Project: Mankato to Mississippi River Project  
23-157

**Supplemental Information Inquiry 2**

Project: Mankato to Mississippi River Project  
23-157

## System Illustrations for Supplemental Information Inquiry 2, Question 7

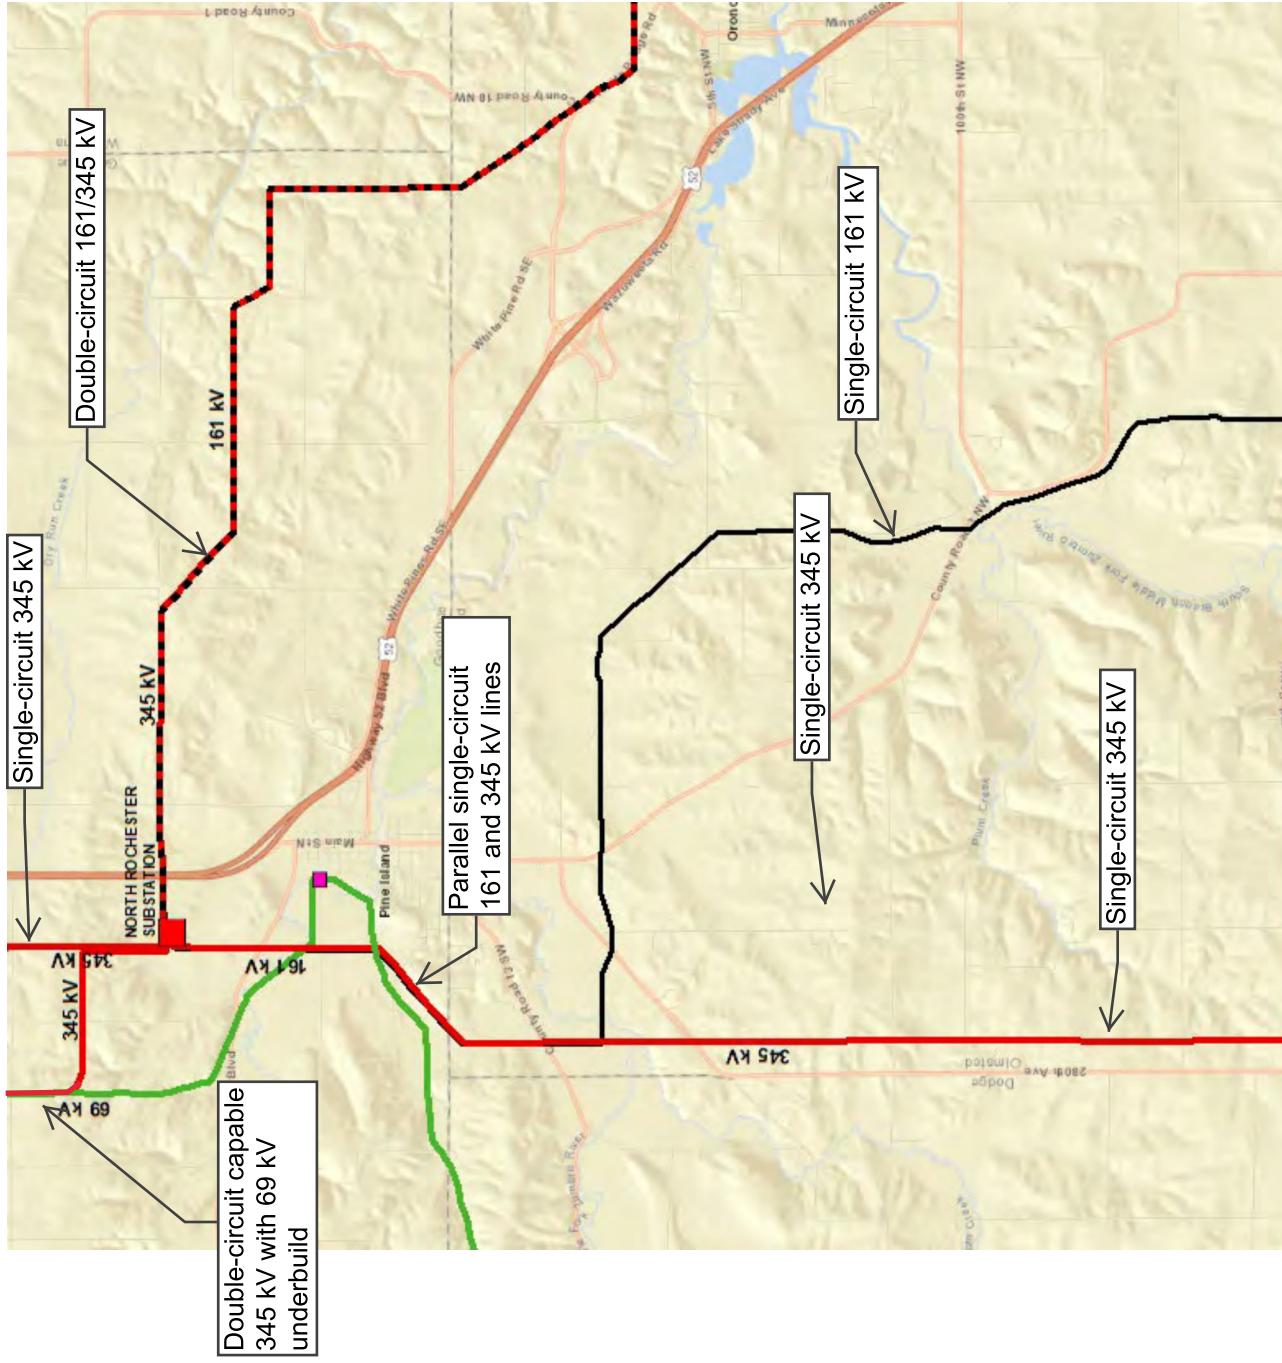
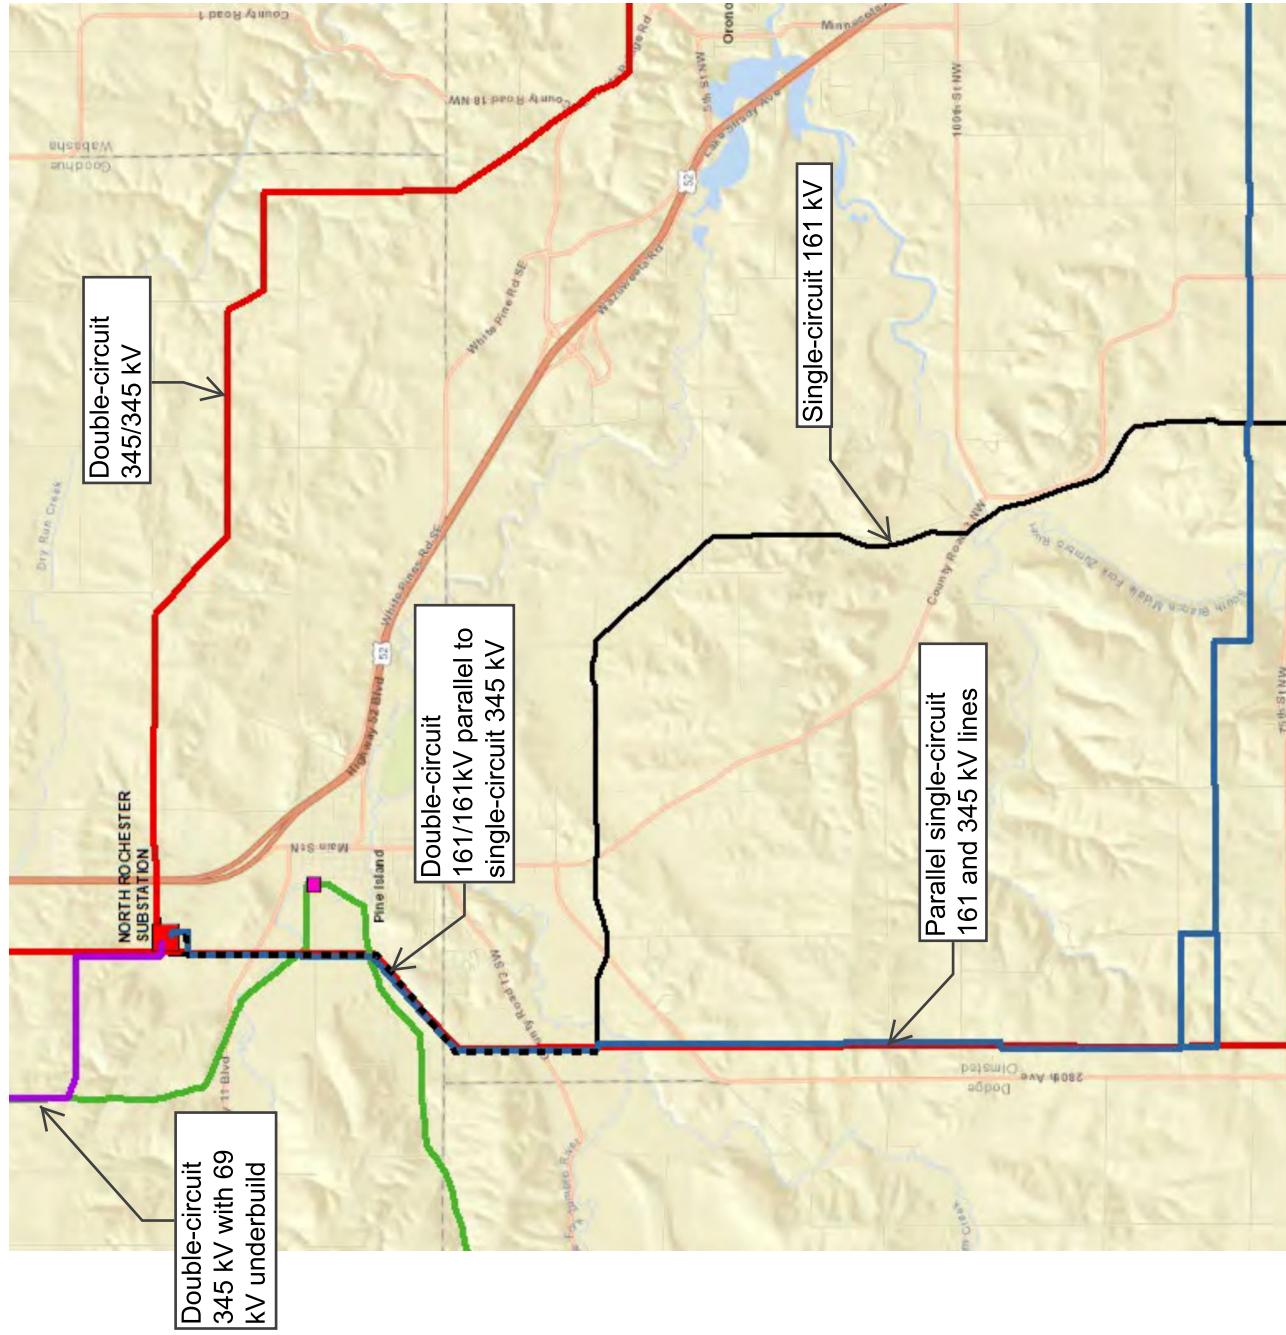
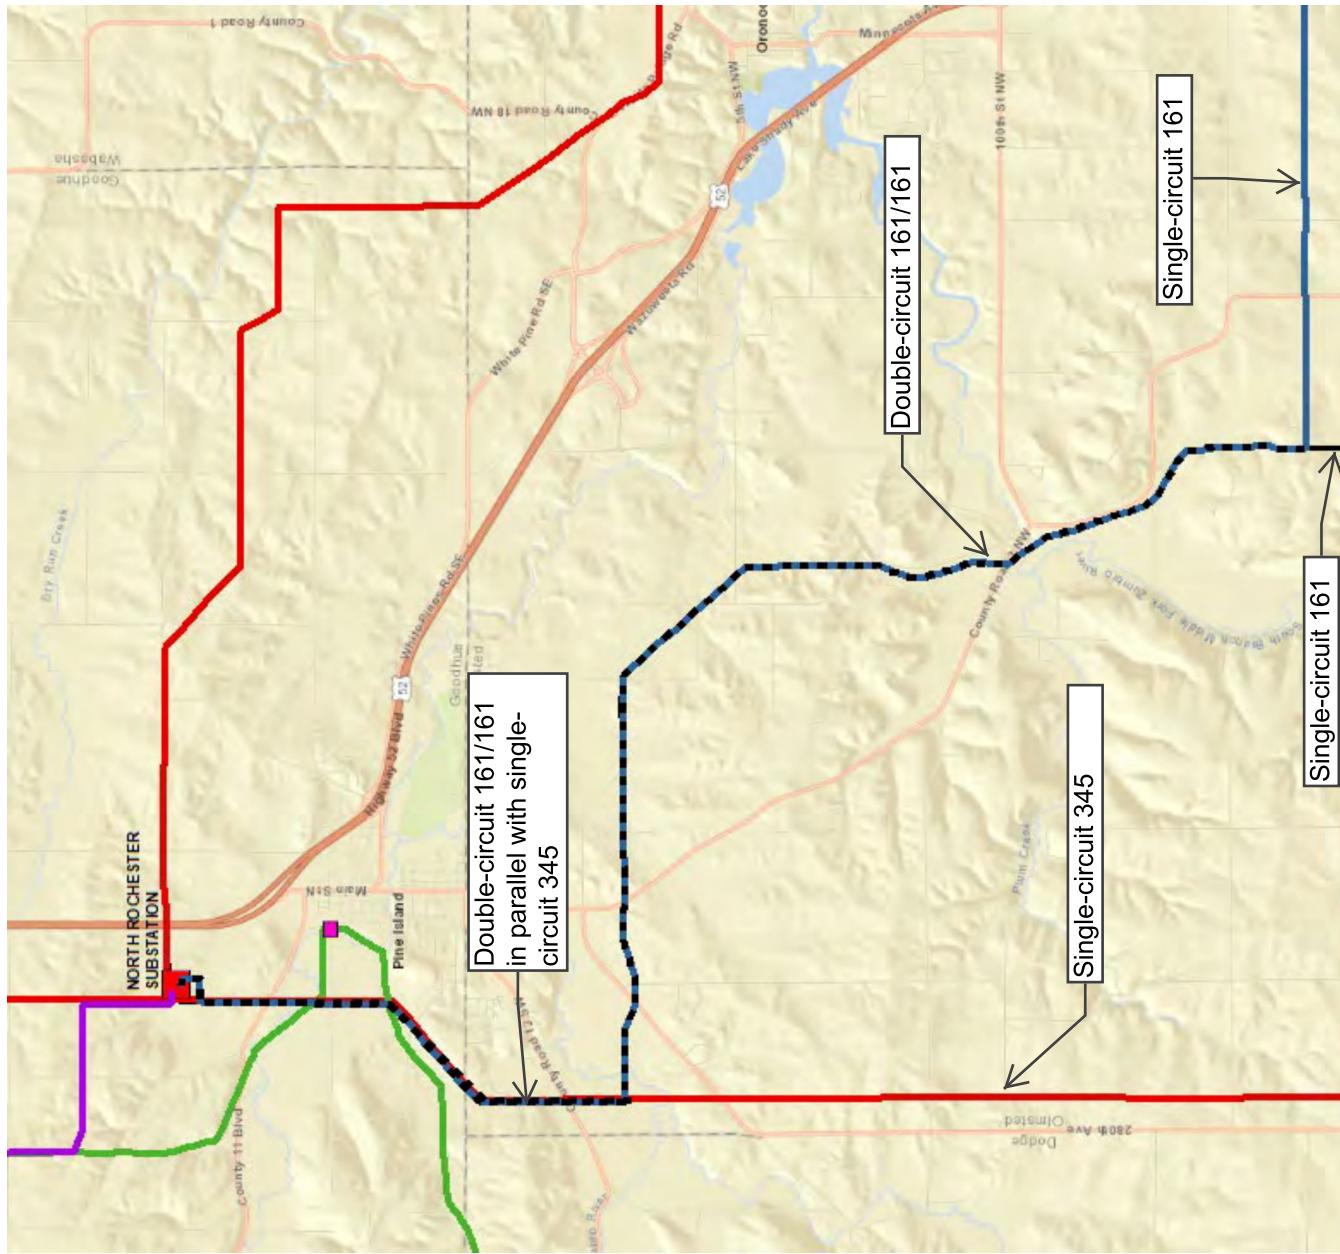
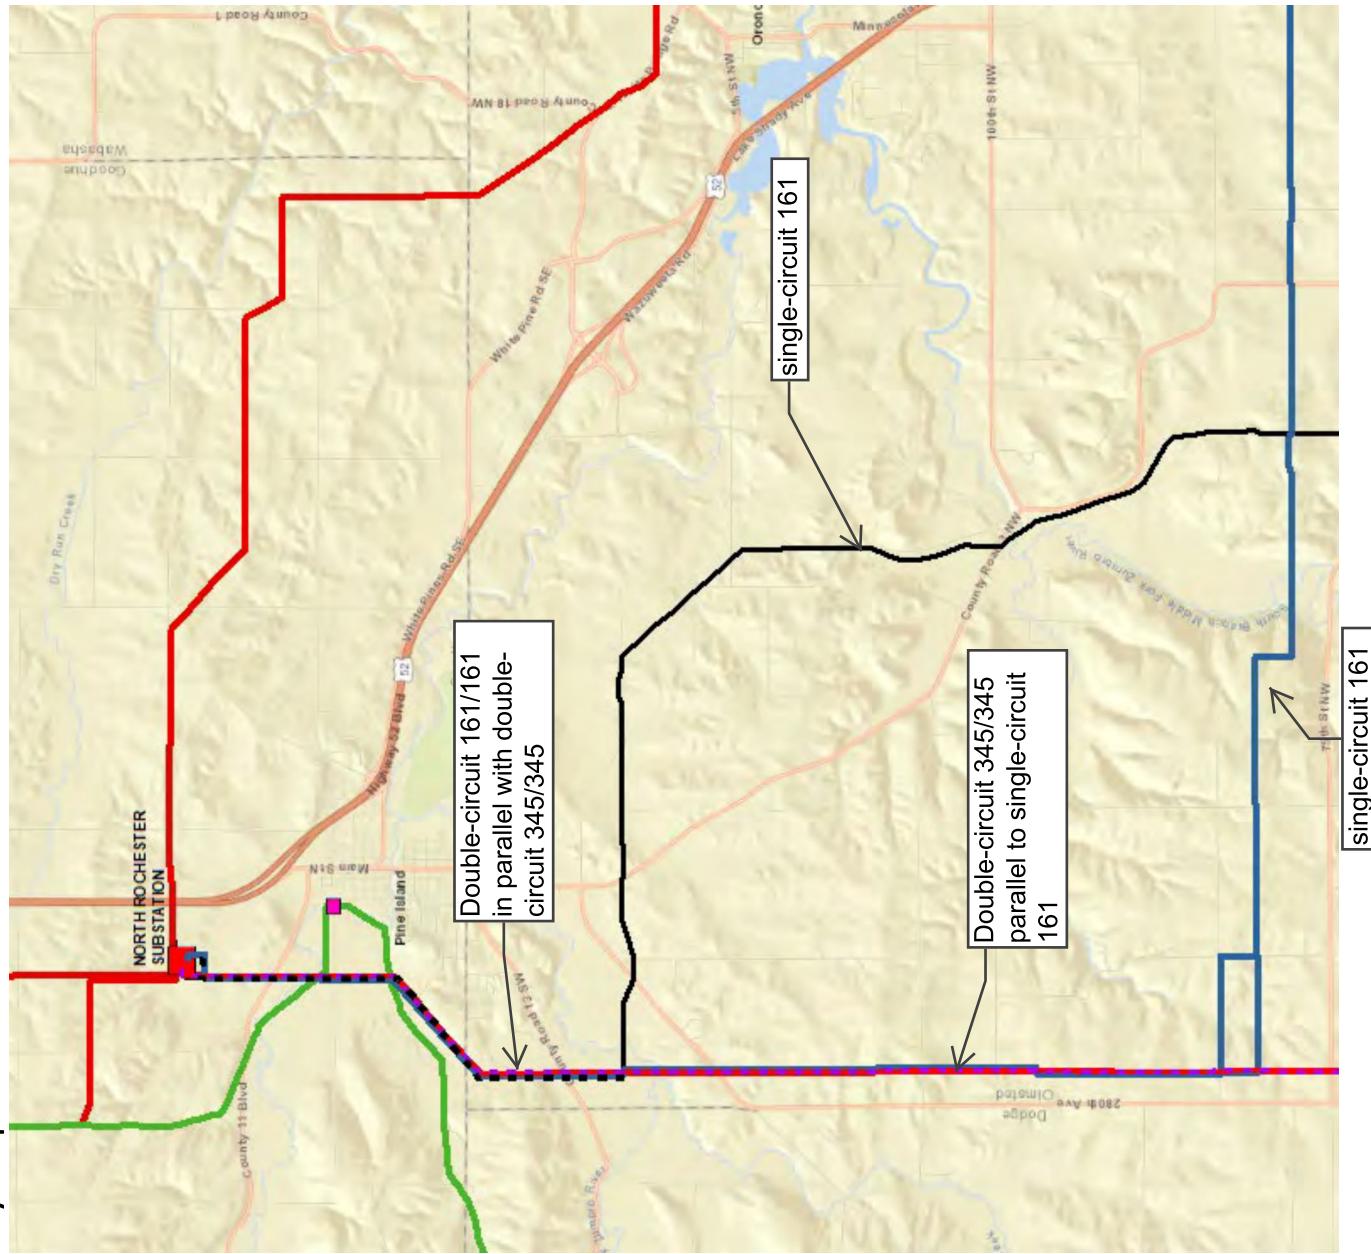
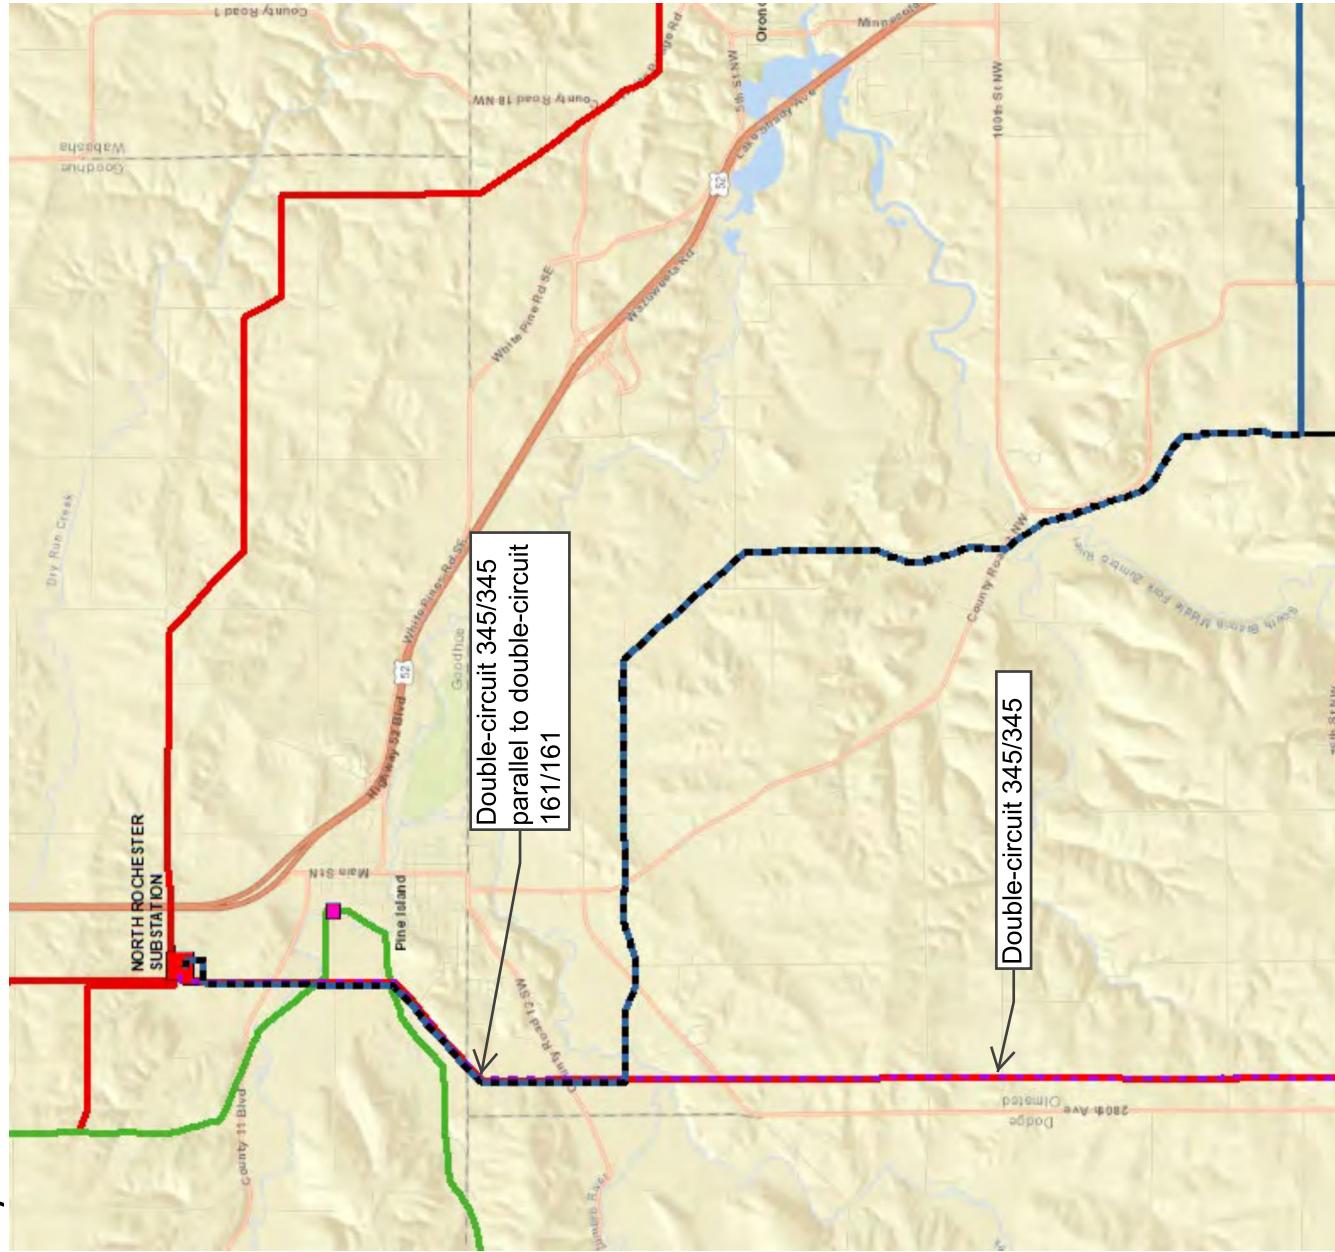
7. This request pertains to Route Segment 17 (Hwy 14 option). In a meeting between Xcel and EERA held on 10/02/2024, EERA and Xcel discussed means of defining an anticipated alignment for the Route Segment 17 (Hwy 14 option). Xcel reiterated that the Route Segment 17 (Hwy 14 option) would need to terminate at the North Rochester Substation (which is also where the applicant's proposed Segment 2 terminates). Xcel's August 28, 2024 letter also noted the need to terminate this alternative at the substation; specifically, your letter stated: "As the Project requires a connection to the North Rochester Substation, a Highway 14 Route Alternative (Hwy 14-ALT) would need to also include a new 345 kV connection from the Byron Substation north to the North Rochester Substation." As discussed on 10/02/2024, it is EERA's understanding that should Segment 4 West (as proposed in RPA, this includes: 4K, 4L, 4N, 4H, 4O, 4P) be selected by the Commission as part of the final route, the anticipated route corridor for the portion of the Route Segment 17 (Hwy 14 option) going north/south between the Byron Substation and the North Rochester Substation would be one in the same as the north/south portion of Segment 4 West between the Byron Substation and the North Rochester Substation. Xcel noted this would imply that there could be two lines running north/south. Please confirm that two lines running north/south in this area would be constructable and feasible. Please also confirm if double circuiting is a potential in this area.

Segment 4 of the MIMRT project includes the relocation of a portion of the 161 kV line between North Rochester and the Chester Substation (east of Rochester). No portion of the Segment 4 is proposed to be double-circuited with the existing 345 kV line (see question 5 above for more on this item). If Segment 4 West is selected approximately 3.3 miles of the new line would be double-circuited with the existing North Rochester to Northern Hills 161 kV line. If Route 4 West-A is selected approximately 11.3 miles would be double-circuited with the existing 161 kV line.

Note, there are a number of existing lines in this area that connect to the North Rochester Substation. The enclosed System Illustrations for Supplemental Information Inquiry 2, Question 7 shows the configuration and locations of the lines that would result from the project for the following potential route choice combinations:

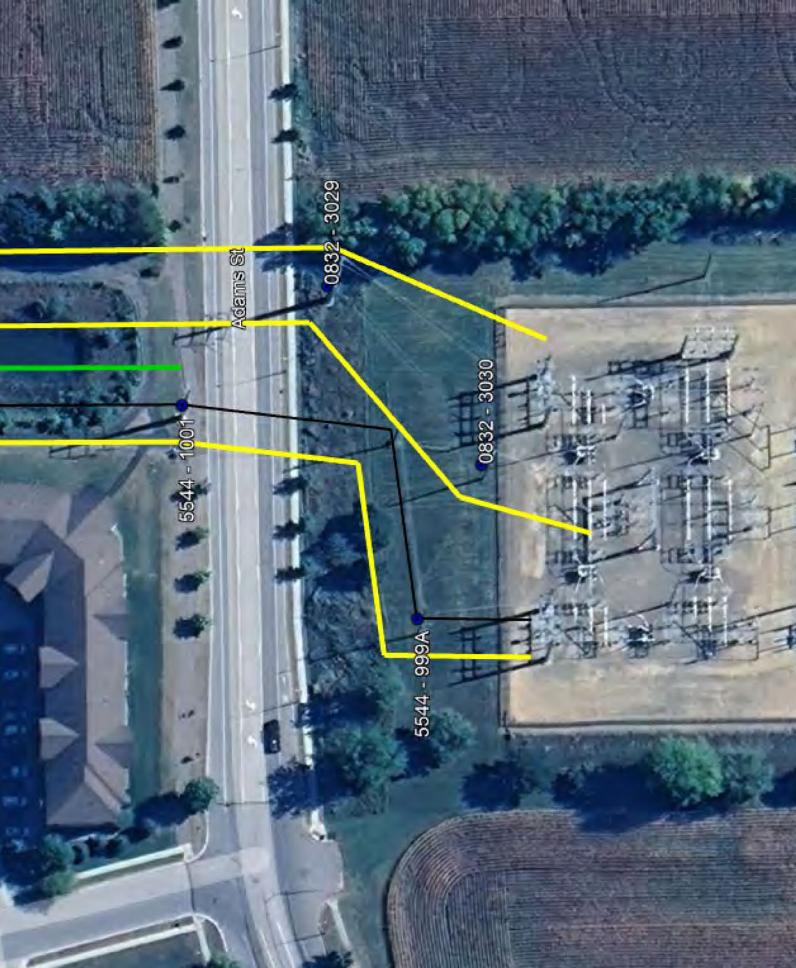
1. The joint certificate of need application and route permit application indicates the Wilmarth Substation would be upgraded to include new substation equipment. It also notes the expansion area would be approximately 0.8 acre in size located on the northeast corner of the existing substation. To better understand potential impacts for the upgrades to this substation, please provide:

- f. Please provide an estimated duration of construction activities at the substation.

**The total time to construct the proposed expansion of the Wilmarth Substation (grading + equipment installation) is expected to be 1-1.5 years. However, this timeline is dependent upon various factors (e.g., supply chain, material availability, workforce/labor, weather, outage windows, etc.) and may change as the start of construction time nears. Xcel Energy estimates it will require approximately 10 weeks to complete grading for the pad expansion.**

**Option 1 South transmission reconfiguration at Eastwood Substation**

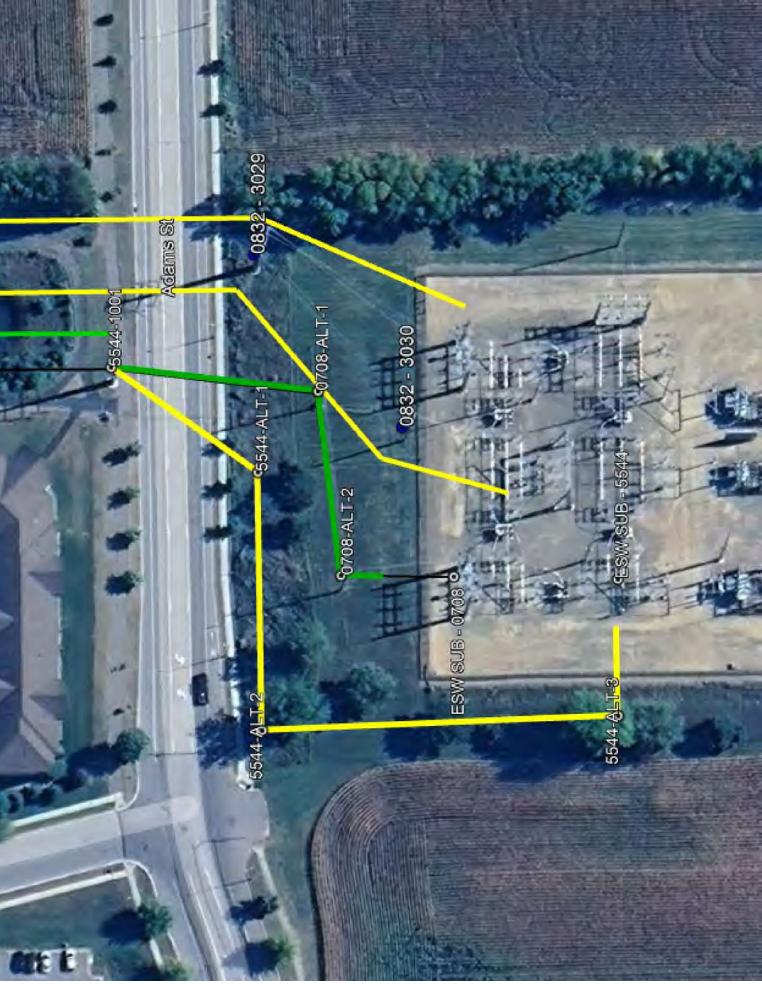
- c. It is also EERA's understanding that if Route Option 1 South were selected, 500 feet of new 69 kV transmission line would be installed to connect the existing line into the substation. Please provide a shapefile indicating where the new 500 feet of transmission line would be located and additional information on why it would be needed.

Yes, that is correct. See screenshots below and attached MMRT\_EastwoodSub\_Shapefiles\_20250124. The additional 500 feet of 69 kV is necessary to connect the line to the Eastwood Substation. The first figure shows the existing configuration where the 69 kV line (green) terminates just north of the substation but does not connect to the substation. The second figure shows the proposed re-termination for the 115 kV line 5544 and proposed new termination of 69 kV line 0708 into the Eastwood Substation.
